Access Compliance Report

Public Rights-of-Way

Intersection ID: 12056	Main Street: ELLIOTT_ST	Cross Street: W_MOREHEAD_ST	Location: SE
ADA ID: B93EF9F2AF79	Ramp Type: BlendTrans1	Initial Pass/Fail: Pass	Overall Compliance: No
Severity Score: 0			
Codes/Mitigation Info/Possible Solution		Field Measurements/Component Compliance

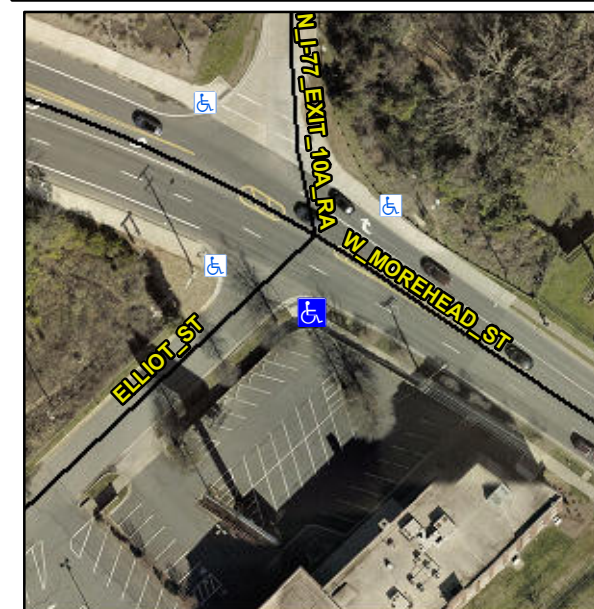
LNDG LINE IS NOT PERP TO RAMP

R305.2

Remove & Replace Detectable Warning System.
